City of Ketchum Planning & Building

PROJECT: Swan Stream Alteration/Bank Stabilization

PERMIT #: Amendment to Permit P18-131

REQUEST: Amendment to permit P18-131 issued October 19, 2019. Construction has not commenced. Permit remains valid under an administrative extension. Scope of work includes stream alteration, bank stabilization, land reclamation and restoration.

C.5 SECTION 105
 HORIZONTAL SCALE: 1" = 15'
 VERTICAL SCALE: 1" = 5'

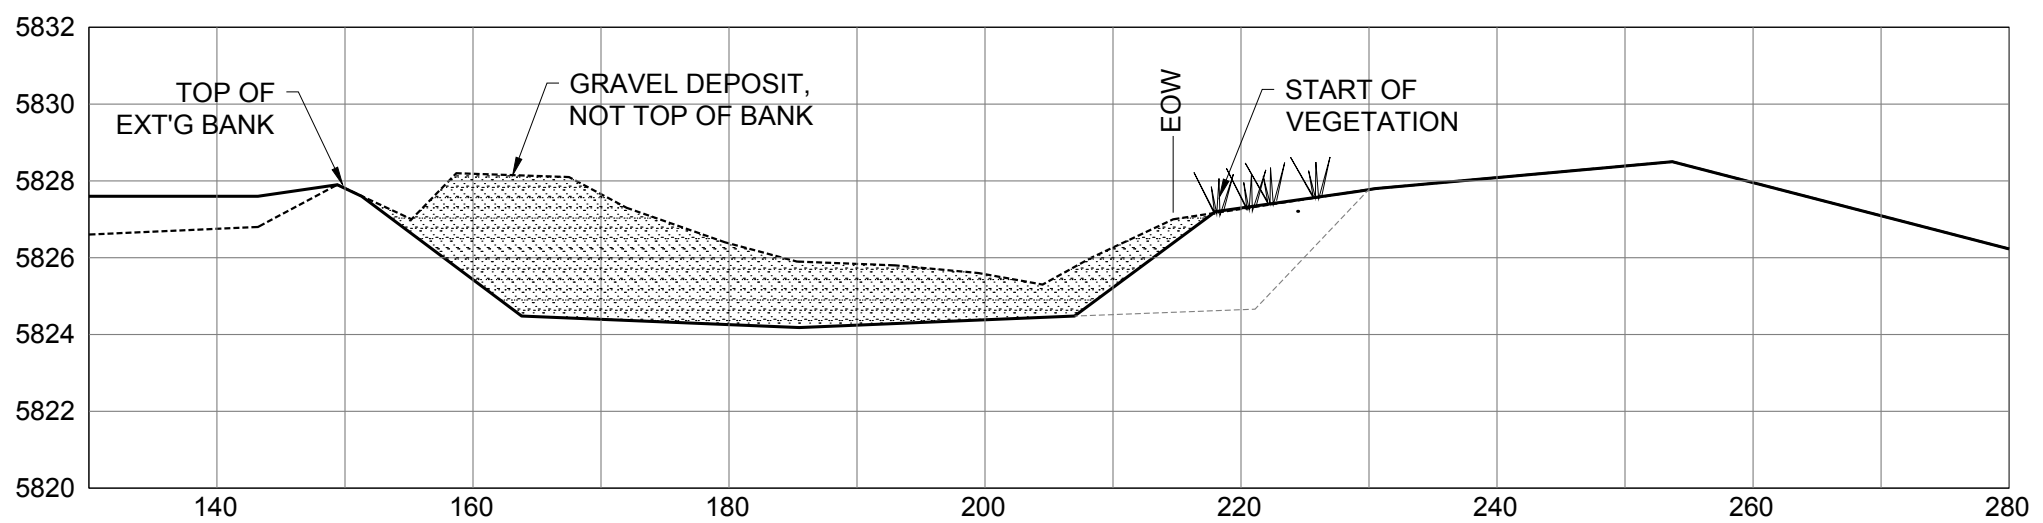
- The proposed amendment to the plans originally approved via P18-131 does not create a stable situation or permanent solution. The amendment to the project, as designed, increases velocity at Cross Section 105 at flows of 1,000 cfs. Velocity increase at lower, more frequent flows can cause erosion of unstable banks.
- Without bank stability components on 411 Northwood Way originally included in the project but proposed to be removed with this amendment, the elevation of the rock sill has been designed to promote bed erosion and downcutting of the channel upstream of the project onto the 411 Northwood Way property. This will cause the channel to create the hydraulic conditions included in the original design but without the previously proposed bank protection.

- The proposed amendment to the plans originally approved via P18-131 does not create a stable situation or permanent solution. The amendment to the project, as designed, increases velocity at Cross Section 105 at flows of 1,000 cfs. Velocity increase at lower, more frequent flows can cause erosion of unstable banks.
